APPLICATION UNDER HOBART INTERIM PLANNING SCHEME 2015

Type of Report: Committee
Council: 3 June 2019
Expiry Date: 25 June 2019
Application No: PLN-19-145
Address: 56 ATHLEEN AVENUE , LENAH VALLEY
ADJACENT ROAD RESERVE
Applicant: PETER LIDDINGTON
23 SPINNAKER CRESCENT
Proposal: Dwelling
Representations: Nil
Performance criteria: General Residential Zone Development Standards, Parking and Access Code, Stormwater Management Code

Figure 5. Excerpt from submitted plan Drawing 803 (Project 1819-14 dated 14/3/2019).

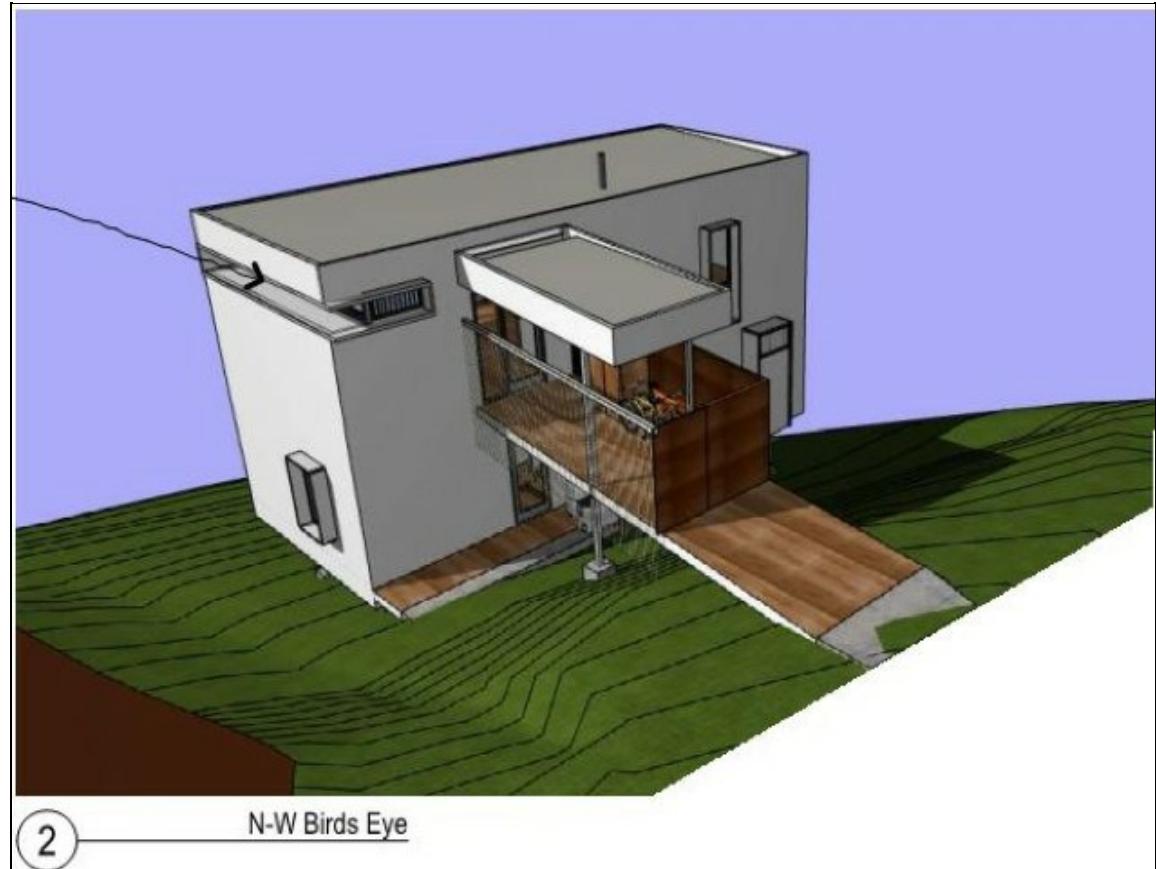
6.10.2 The proposal includes a gate on the front boundary and a section of wall (partly within 4.5m of the frontage) on the edge of the entry ramp / bicycle parking area that would be a 2.5m wide x 1.8m high solid corten steel fence and gate. See Figure 5 paragraph 3.4 above.

The gradient of the site is a factor in the access ramp design. The extent of the gate is minimal, and although only setback 1m from the property boundary, will appear to be more set back than that because of the generous nature strip at the back of the footpath. The gate is not considered to have an unreasonable impact on the streetscape, and will allow for mutual passive surveillance of the house and street.

- 6.10.6 The proposal complies with the performance criterion.

Figure 5. Excerpt from submitted project 1819-14 drawing 201 (14/3/19) showing building envelope over building, east / downhill side elevation.

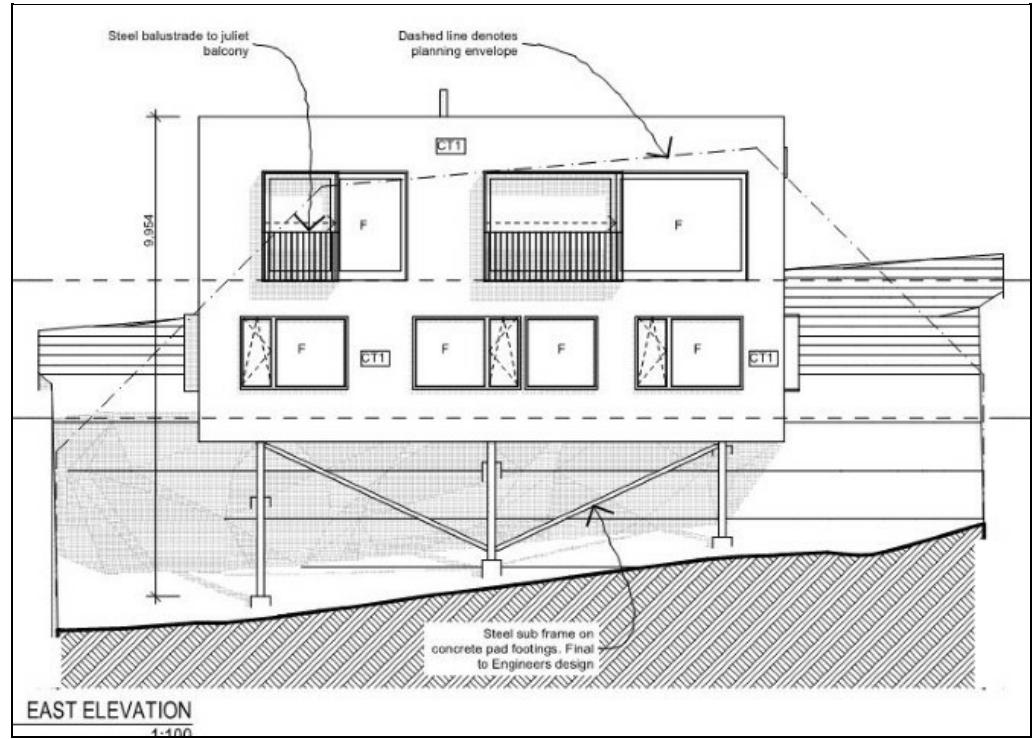
- 6.8.2 The proposal includes development outside of the prescribed envelope.

- (b) provide separation between dwellings on adjoining lots that is compatible with that prevailing in the surrounding area.*
- 6.8.5 The building is designed to be only ~5m wide at its northern and southern elevations, and would be set back ~3m from the southern boundary. The highest point of the building would be ~10m from natural ground level on the eastern / downslope side.

- The building is likely to have some impact on access to sunlight of the adjacent dwelling on 58 Athleen Avenue, to the south, but not unreasonably so, particularly noting the slope of the site.

- 6.8.6 The proposal complies with the performance criterion.
- 6.9 Private open space for all dwellings D10.4.3 P2
- 6.9.1 The acceptable solution at clause D10.4.3 A2 requires that a dwelling must have an area of private open space that is, amongst other things - in one location and is at least 24 sqm; has a minimum horizontal dimension of 4m; and is directly accessible from, and adjacent to, a habitable room (other than a bedroom).
